WELL API NO. 30-015-32028
5. Indicate Type of Lease STATE <input checked="" type="checkbox"/> FEE <input type="checkbox"/>
6. State Oil & Gas Lease No. V-2597
7. Lease Name or Unit Agreement Name FLORA AKF STATE
8. Well Number 4
9. OGRID Number 25575
10. Pool name or Wildcat LOST TANK; DELAWARE
11. Elevation (Show whether DR, RKB, RT, GR, etc.) 3510' GR

SUNDRY NOTICES AND REPORTS ON WELLS
 (DO NOT USE THIS FORM FOR PROPOSALS TO DRILL OR TO DEEPEN OR PLUG BACK TO A DIFFERENT RESERVOIR. USE "APPLICATION FOR PERMIT" (FORM C-101) FOR SUCH PROPOSALS.)

EOG proposes to P&A this wellbore ASAP using the following procedure:

Current Wellbore Diagram:

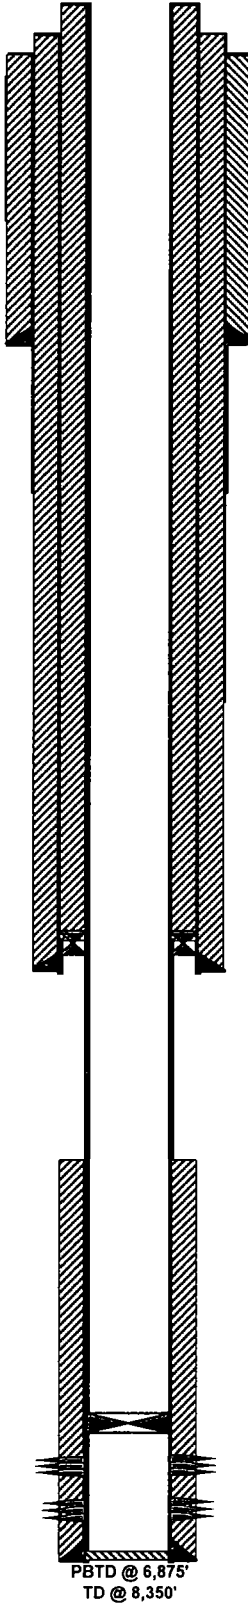
Need CIBP Above Parts
Need Proposed WBD

For State Use Only
 APPROVED BY: **DENIED** TITLE **DENIED** DATE 8-24-18
 Conditions of Approval (if any):
